SUBJECT: Bulletin "C" Dated May 7, 2020
PROJECT #: A1310-00
DESCRIPTION: Restoration Upgrades to Exterior Building Envelope
State Office Building - 135 Hanover Street
Trenton, Mercer County, NJ

PROJECT#: A1310-00 Restoration Upgrades to Exterior Building Envelope
State Office Building
135 West Hanover Street,
Trenton, Mercer County, N.J.

BULLETIN “C”

Sheet No.
A200
Sheet 13 of 20
©Lamme + Giorgio 2019

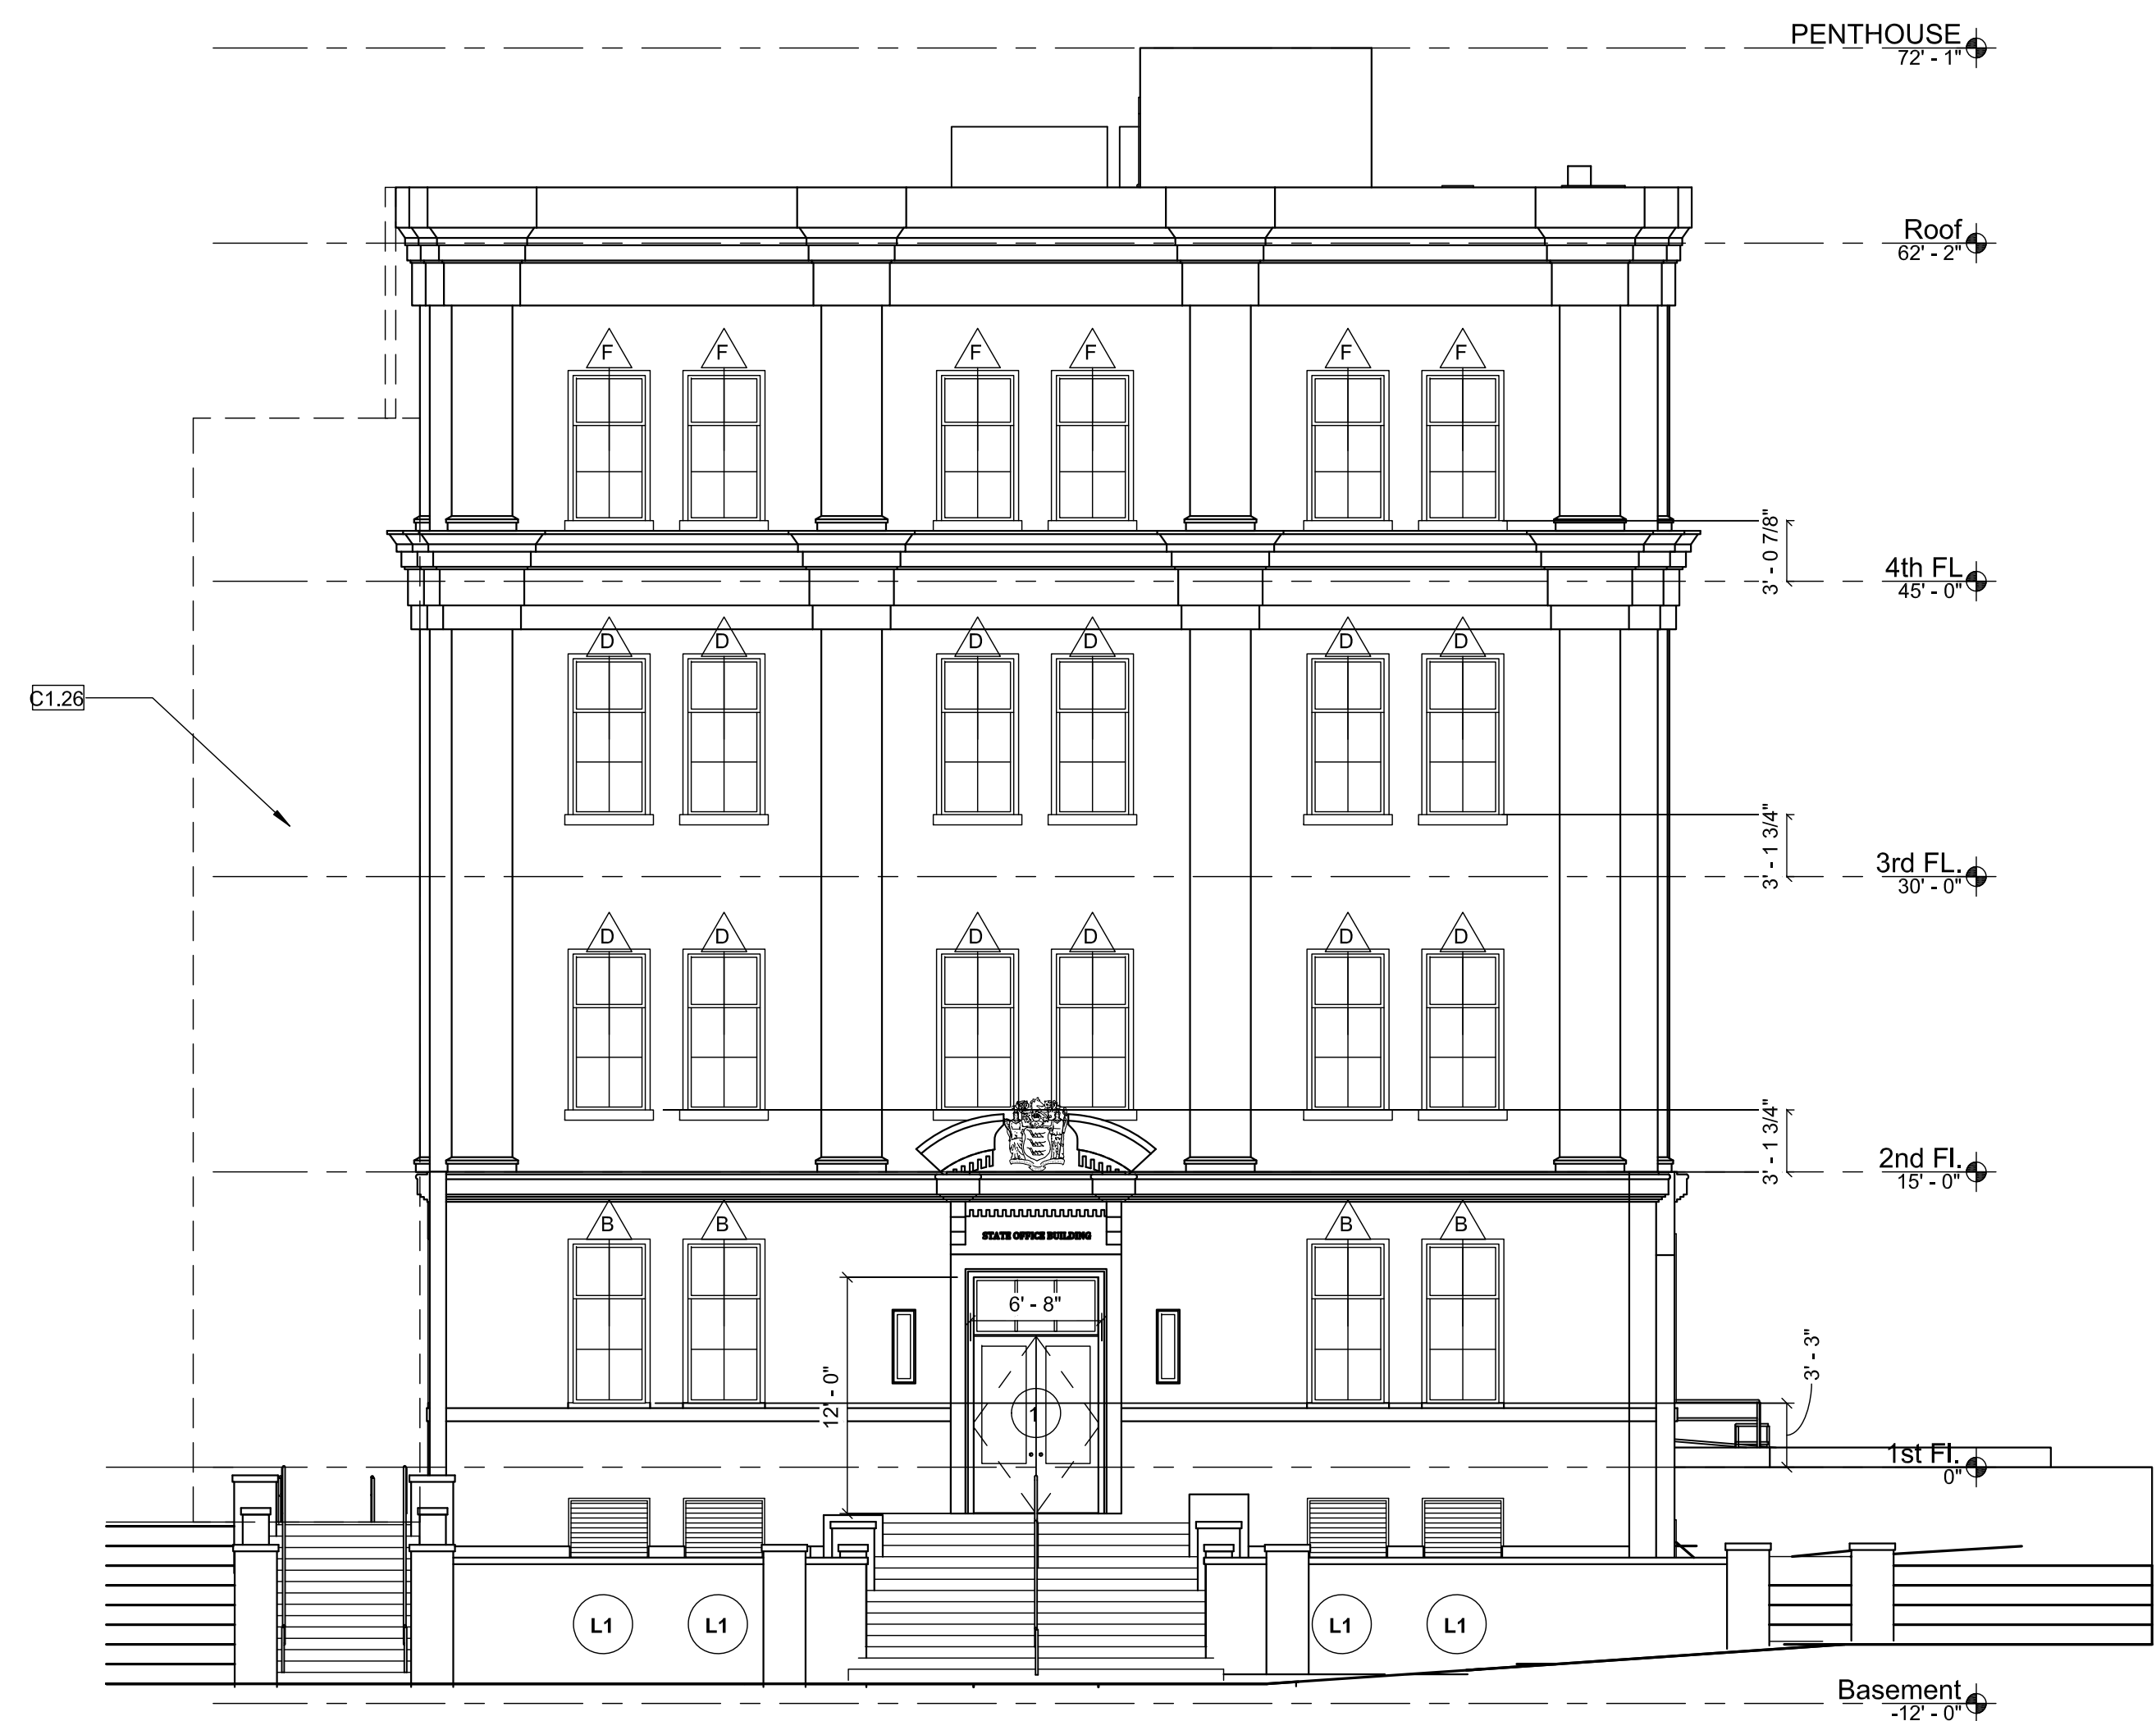
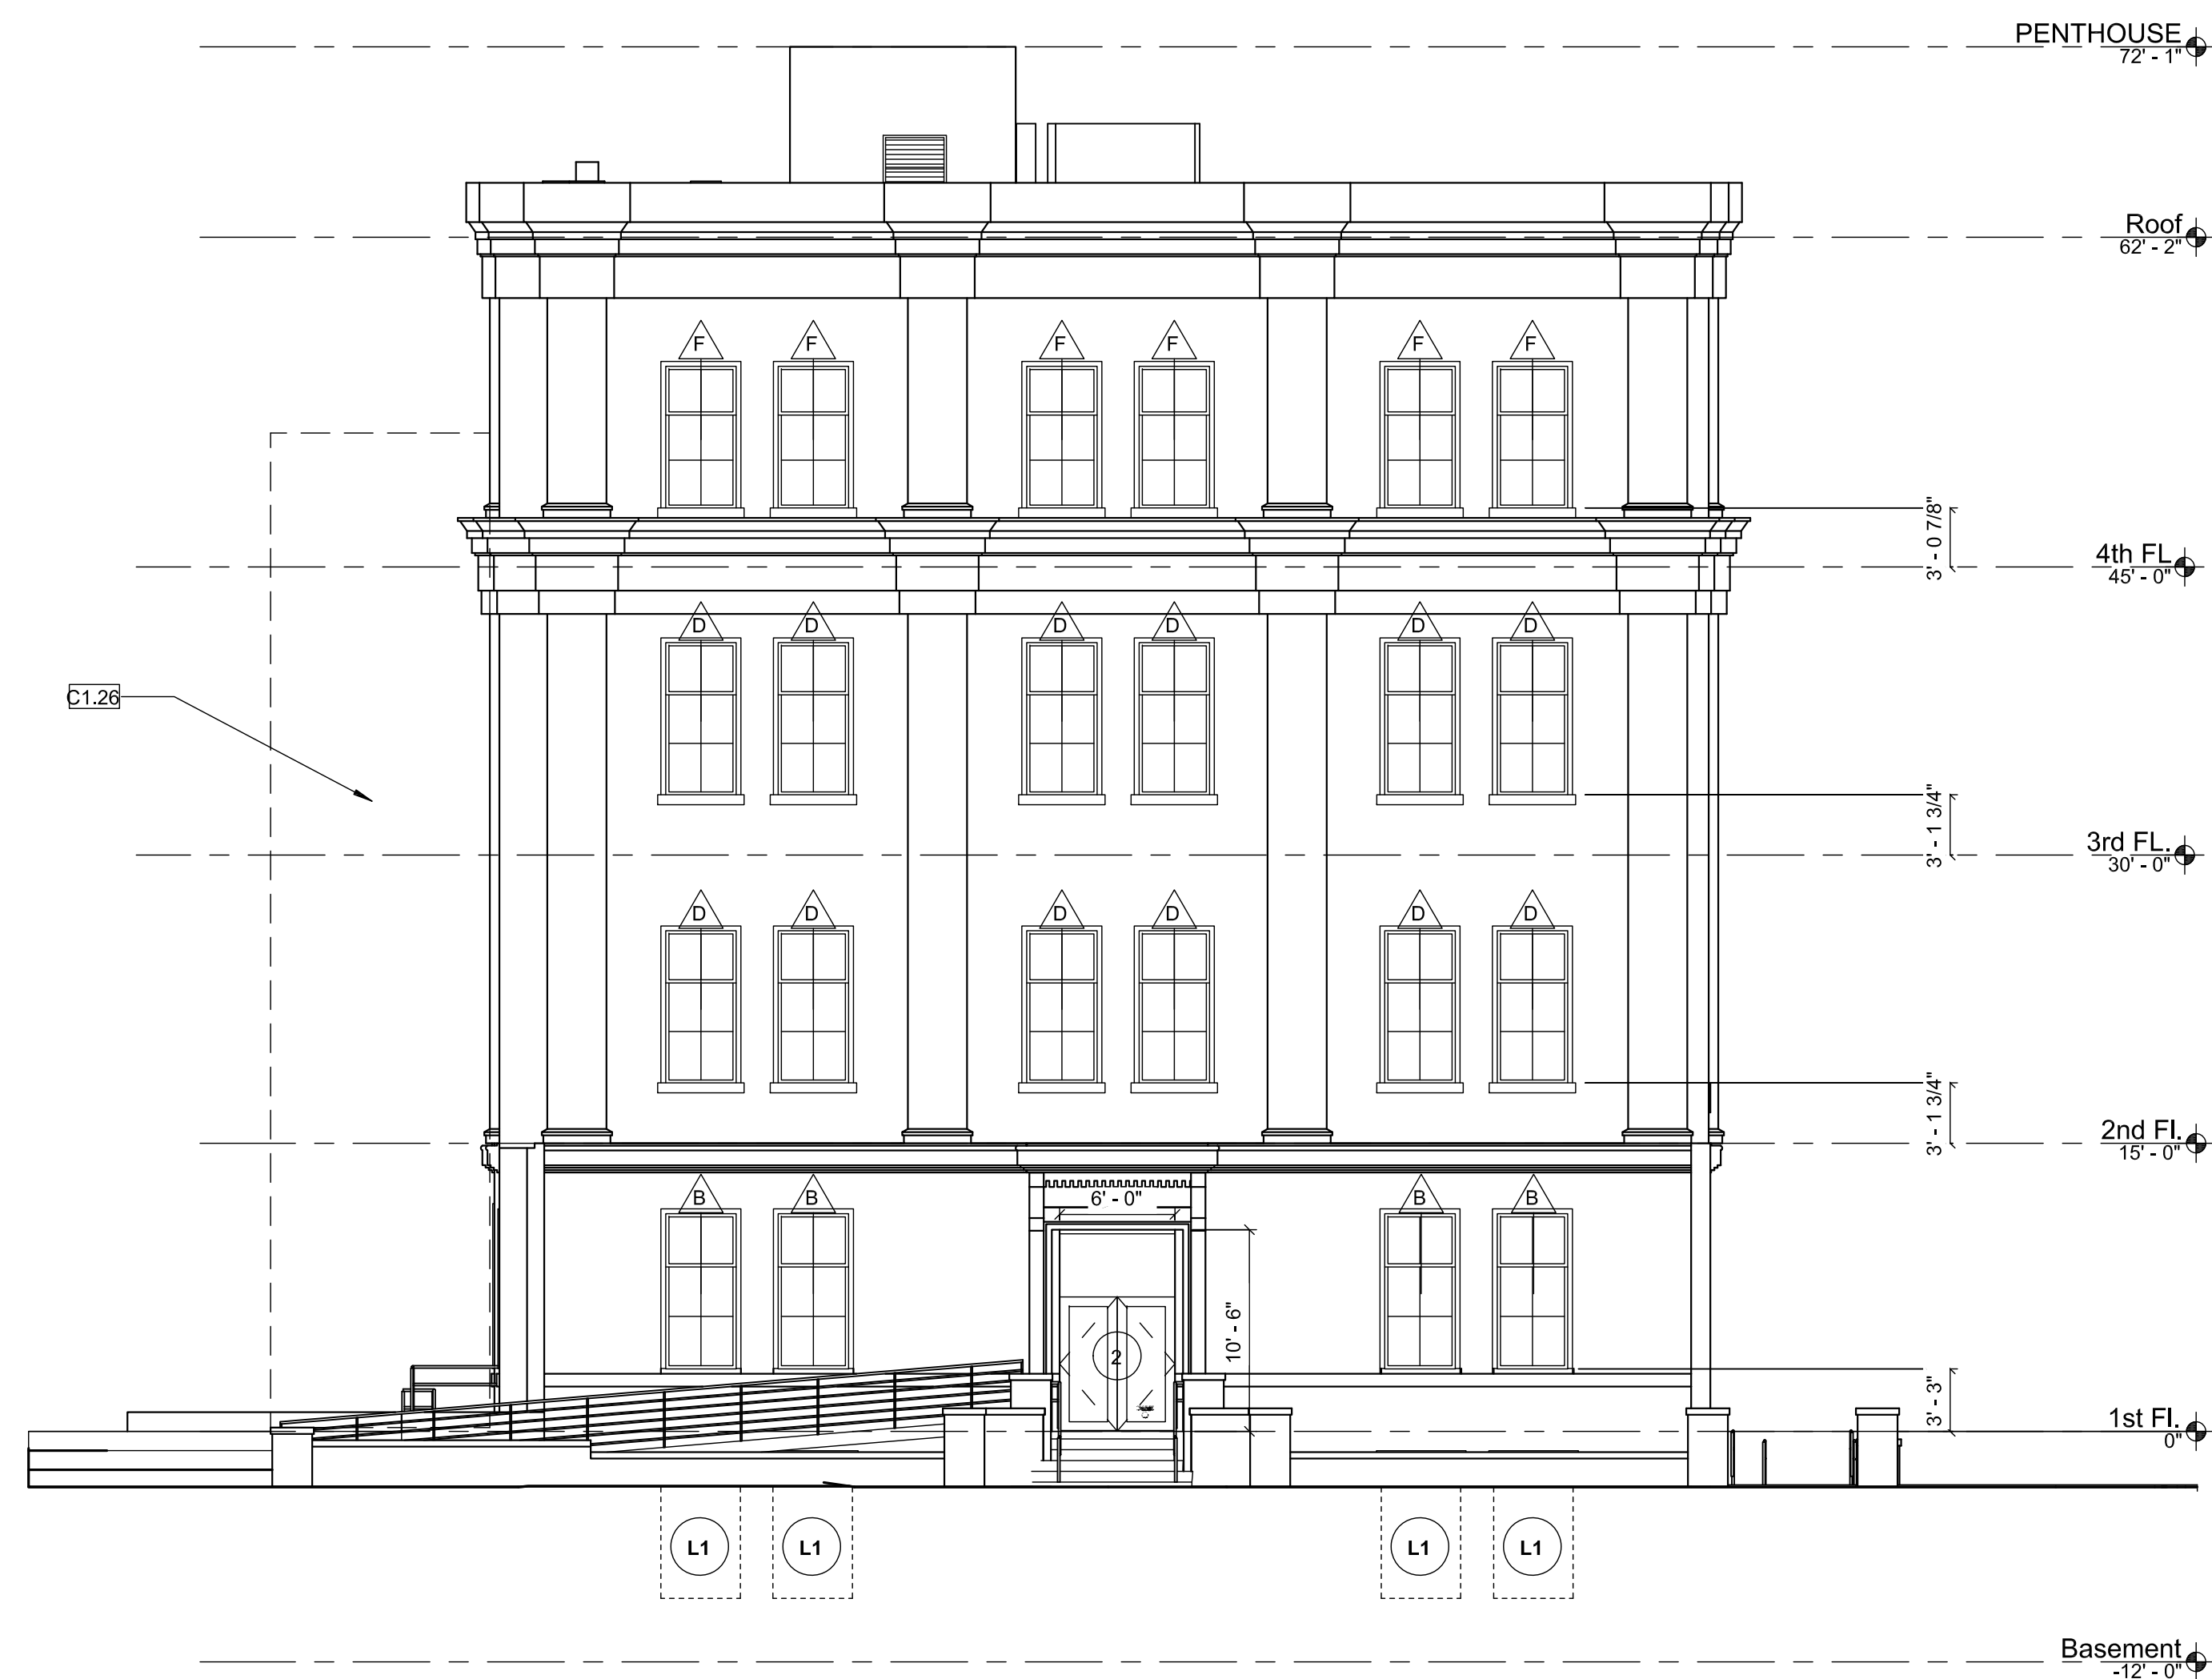
1. Are Marvin Windows an acceptable manufacturer for the replacement windows?
RESPONSE: Marvin Windows is an acceptable manufacturer for the new windows. See attached “Revised Drawing A103”, “Revised Drawing A200”, “Revised Drawing A201” and “Revised Specification Section 085250” for more information.
2. Is there any underground plumbing work required?
